## ***Interactive comment on “Structural geology and geophysics as a key to build a hydrogeologic model of granite rock to support a mine” by L. Martinez Landa et al.***

SE-2016-27-RC1-Reply: Replies (in colors for clarify) have been added as a supplementary pdf file.

**Fig. 1.** Figure 4: Some of the chemical and geophysical logs recorded at borehole SR1, which helped to identify dyke 27 and fracture SR1-3. The chemical logs only display the effect of dyke 27, because all upp

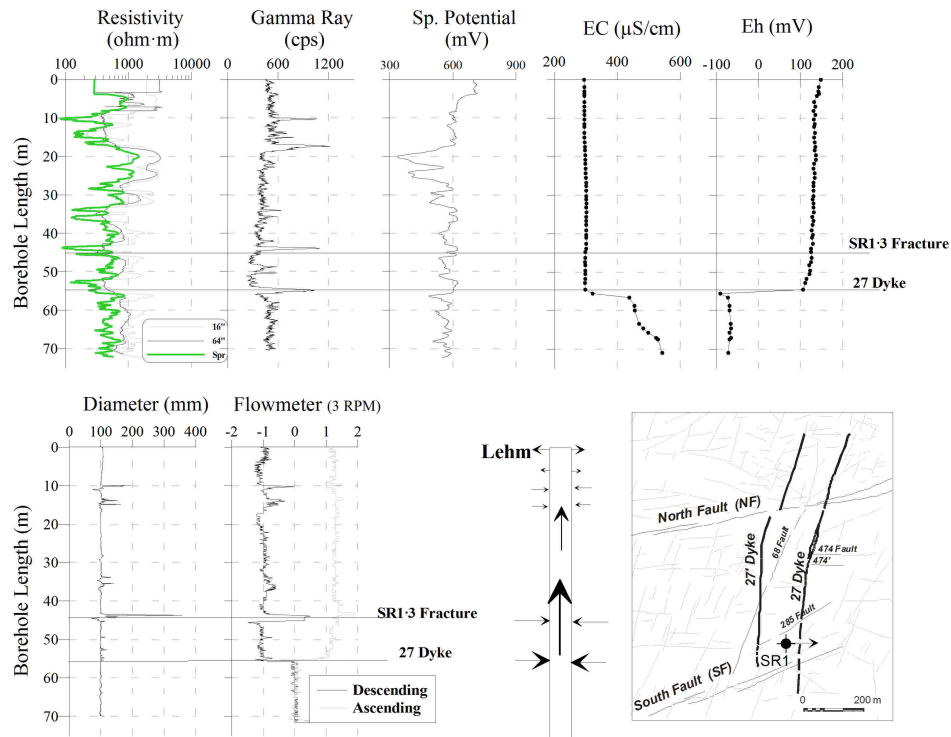
pg 5, line 15: There is no temperature log in Figure 4! Sorry, we had changed the figure giving up some profiles as temperature, pH and dissolved oxygen, but not the text, which now reads: electrical conductivity, redox potential, resistivity, gamma ray, spontaneous potential, diameter and flow meter We have also modified the caption of Fig.4, which now reads: Some of the chemical and geophysical logs recorded at borehole SR1, which helped to identify dyke 27 and fracture SR1-3. The chemical logs only display the effect of dyke 27, because all upper water (including SR1-3) is mine water. The effect of both structures can be noticed in the other logs, especially in the gamma log, due to fracture filling. Flow meter values, recorded with an upward flow-rate of pumping indicate little water flow beneath dyke 27. The same applies to a lesser extent to fracture SR1-3.

Figure 4: I do not see how the geophysical logs helped identify the dyke. There should be a large difference in the gamma log between the granite and the diabase quartz dyke. Please explain. Resistivity is normally plotted using a log scale (done). Also, the resistivity seems quite low for in-tact granite. Please elaborate on this. These logs are performed at the SR1 borehole, which is located on the not mined part of the 27 quartz dyke, but very close of the mined portion. The granite body is strongly weathered and with a high fracturation index at the first 200m depth. It is for this reason that we have made units differentiation inside the granitic body, depending on the state of the granite the hydraulic behavior are different. This explanation could be explaining the measured values. We change the scale of resistivity to log scale. The figure 4 has been modified as follow:
